[Issue No.] GOT-A-0126

[Title] Change to the Country of Origin Statement for the GOT2000 Series Wireless LAN Communication Unit

[Relevant Models] GOT2000 Series Wireless LAN Communication Unit (GT25-WLAN)

1.1 Rating plate

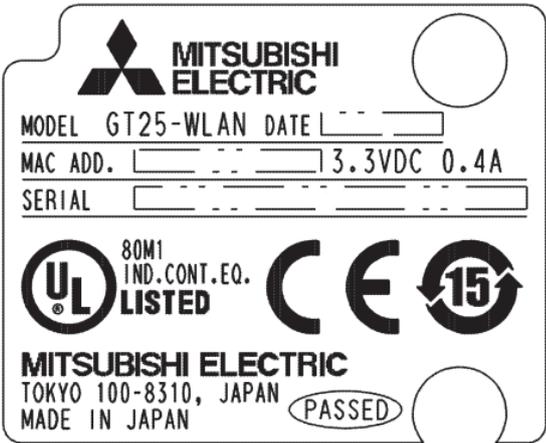
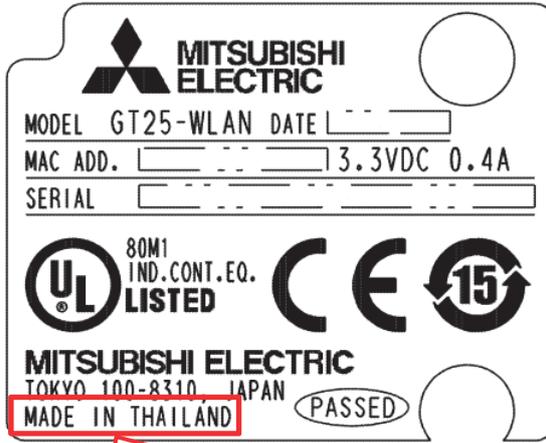
The country of origin statement on the rating plate will be changed.

Before	After
 <p>The rating plate shows the Mitsubishi Electric logo, model GT25-WLAN, date, MAC address, and serial number. It includes UL 80M1 IND. CONT. EQ. LISTED, CE, and RoHS 15 logos. The text at the bottom reads: MITSUBISHI ELECTRIC, TOKYO 100-8310, JAPAN, MADE IN JAPAN, and a PASSED mark.</p>	 <p>The rating plate is identical to the 'Before' version, but the text 'MADE IN THAILAND' is highlighted with a red box. A red callout box points to this text with the text: 'The country of origin statement will be changed to MADE IN THAILAND.'</p>
